Design Review Report: EBeam_TR_770

Design Name: EBeam_TR_770

Key Components: MZIs, Ring Resonators, Spiral Waveguides, and Calibration structures.

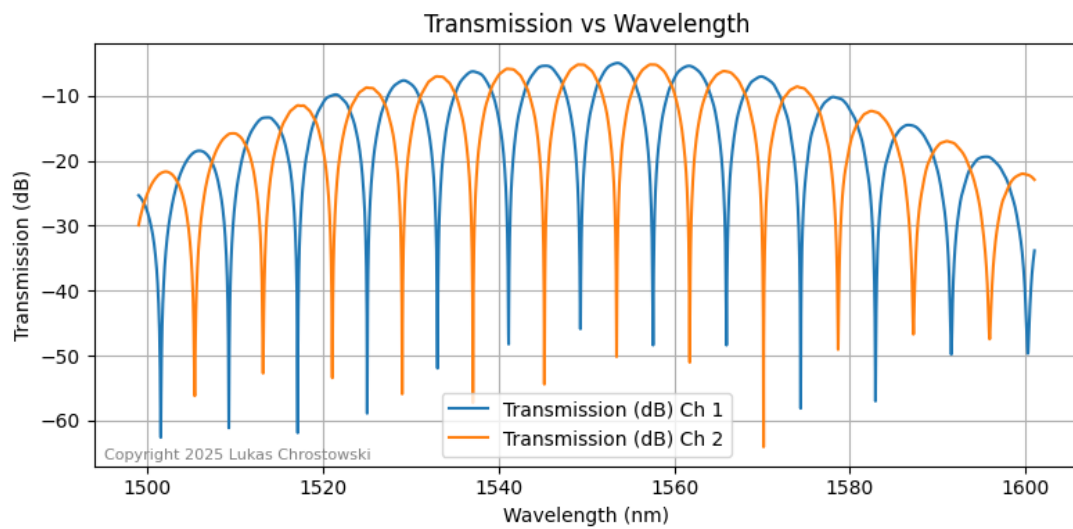
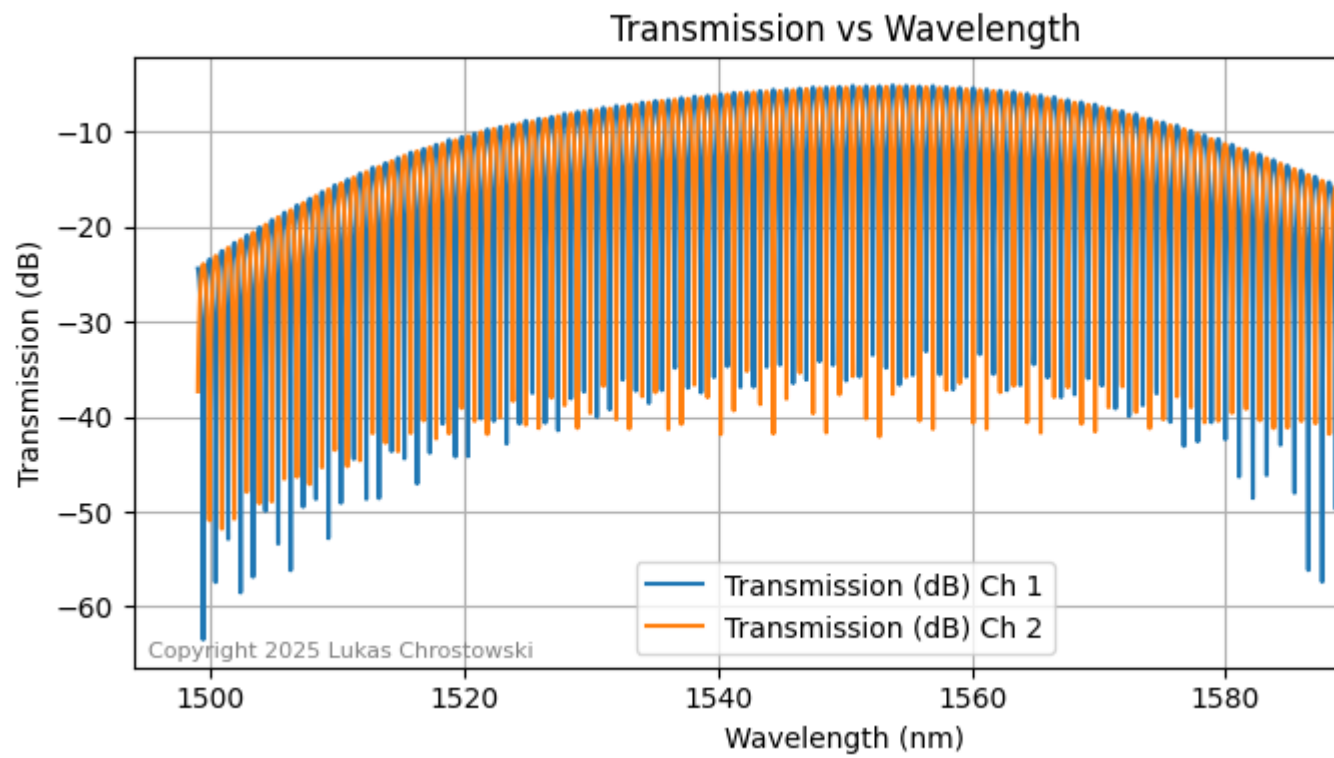
- **Connectivity:** All waveguide paths appear continuous and properly converted to smooth curves. There are no 90-degree "sharp" angles, which is great for maintaining low optical loss.
- **Cross-talk & Spacing:** The floor plan is well-organized. You've left enough "breathing room" (well over 100 μm in most spots) between independent devices to prevent unwanted optical cross-talk.
- **Efficiency:** The layout fits perfectly within the allocated yellow floor-plan boundary and utilizes the space efficiently without being overly crowded.

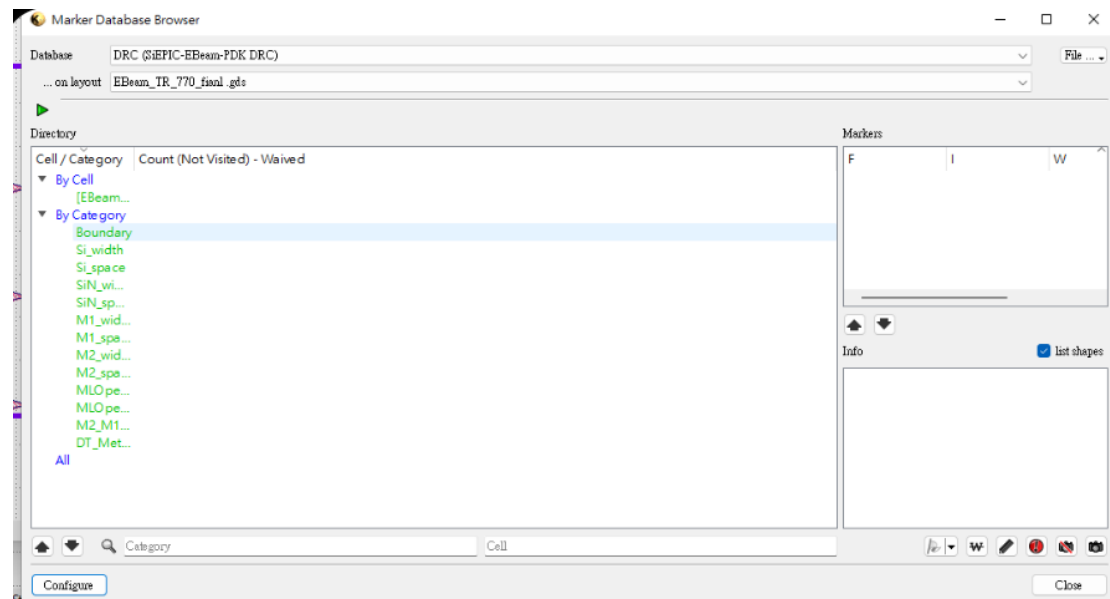
a "Si minimum feature size violation; min 60 nm" error in MZI6.:

text labels for automated measurements:
